BICYCLE AND PEDESTRIAN
ADVISORY COMMITTEE
OCTOBER 10, 2024
5:30 PM
CITY HALL
COUNCIL CHAMBERS
200 LINCOLN AVENUE

- a. Introduction of New BPAC Member (Gary Schiffmiller, District 1)
- b. Presentation of Award Certificates (Chair Michael Garcia)
- c. Otowi Crossing Updates (Bill Adrian, Policy, Planning and Law
Subcommittee Member)
- d. Rabbit Road: Present Condition, Impact of NE/SE Connector Completion
on Safety (Khalil Spencer, former BPAC Vice Chair)
- e. Bishop's Lodge Road 90% Design Review (Dan Painter, Technical

**PASEO DEL SOL EXTENSION
90% DESIGN COMMENTS**

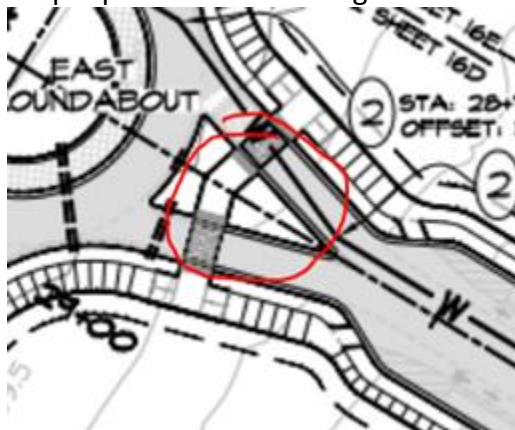
- We would like to have a discussion about the trails that are also being designed and built at the same time. This area is the feasible location for the Arroyo Chamiso Trail and if we can plan and design for that now, we should.
- We're not sure the R9-7 signs will be effective or are necessary on the roundabout designs
- We'd like to see the crosswalk lineup with the trails better here:

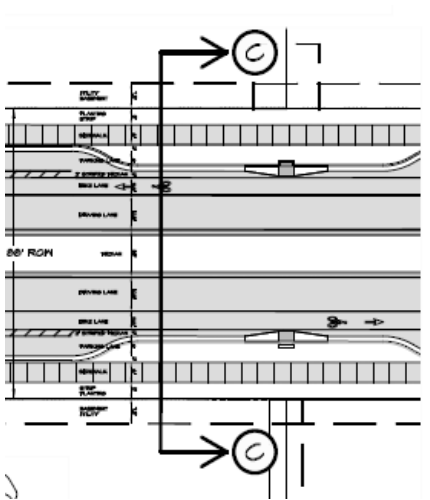
- The connection between Tract E and Tract F both with 30 ft pedestrian easements calls for a marked mid-block crossing of Paseo del Sol. Pedestrians cannot be expected to use nearby unmarked crossings at road intersections. This location will not have the conflicts of intersection traffic, which is an added benefit. Marking this crosswalk and not the others (which remain legal crosswalks) will serve the function per AASHTO of indicating to pedestrians where a good place to cross the street is. Eliminating 1-2 parking spaces on approaches to this crosswalk will reduce screening by parked cars. **Sheet 9B indicates a crosswalk at this location. Several parking spaces have been eliminated. Existing design to remain. Design Enginuity to consider warranted**

countermeasures. All crosswalks to use thermoplastic. Done. Jeannie has requested yield lines be added at the mid-block crossings.

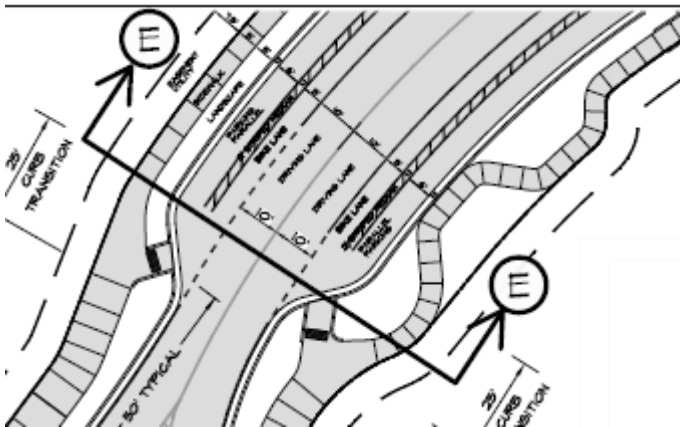
- 70. 10’ multi-modal trail – concrete is preferred to asphalt. Understood. A concrete alternative will be added to the plans and this will be treated as a bid alternative. Done.
- 71. Sheet 8B: Is there a midblock crossing near the (C) cross section? There should be ramps in the median if so. No, there is no midblock crossing at this location. There is one in the between the two roundabouts and a median opening is provided.
